Entergy Operations, Inc.
1448 S.R. 333
Russellville, AR 72802
Tel 501 858 5000

2CAN120106

Subject: Arkansas Nuclear One - Unit 2
Docket No. 50-368
License No. NPF-6
Corrections to the ANO-2 Power Uprate License Application

Corrections to License, Technical Specifications and COLR Pages

FIGURE 2

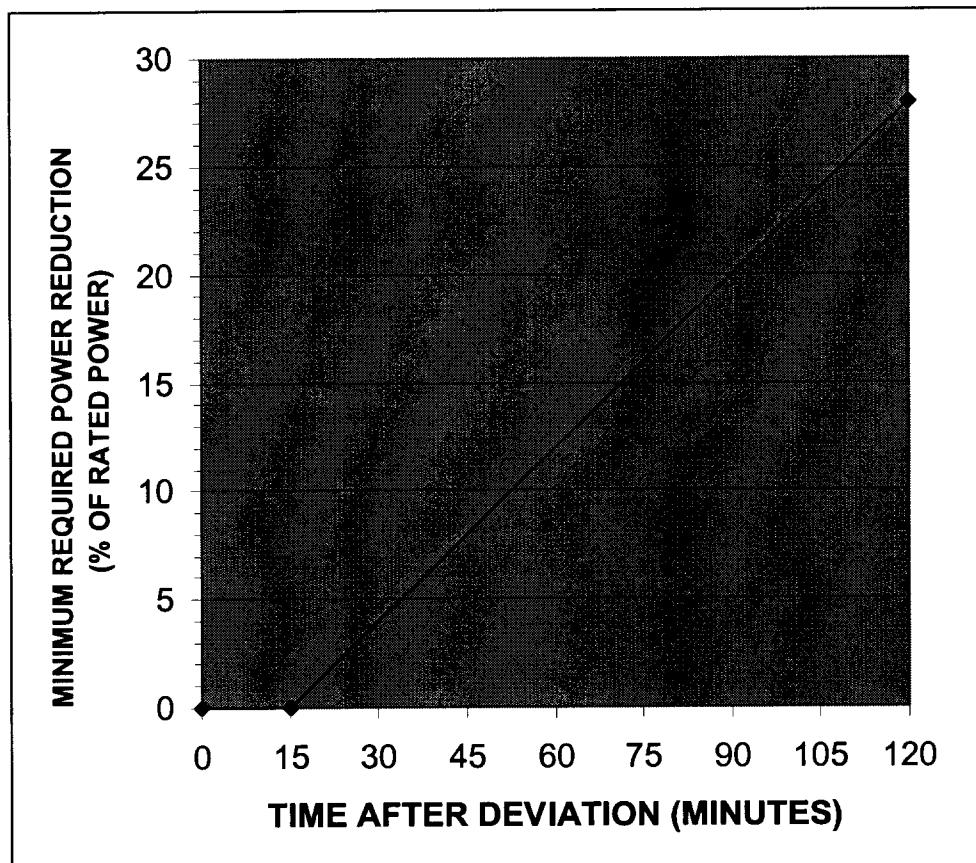
Core Operating Limits Report, Figure 2

The phrase WITH BOTH CEACs INOPERABLE was inadvertently added to the end of the title. The only change to the title was intended to be insertion of the word INWARD between AFTER and CEA. The title should read REQUIRED POWER REDUCTION AFTER INWARD CEA DEVIATION. The title has been corrected.

Existing Figure 2 of the Cycle 15 COLR will be replaced with the following figure:

REQUIRED POWER REDUCTION AFTER INWARD CEA DEVIATION *
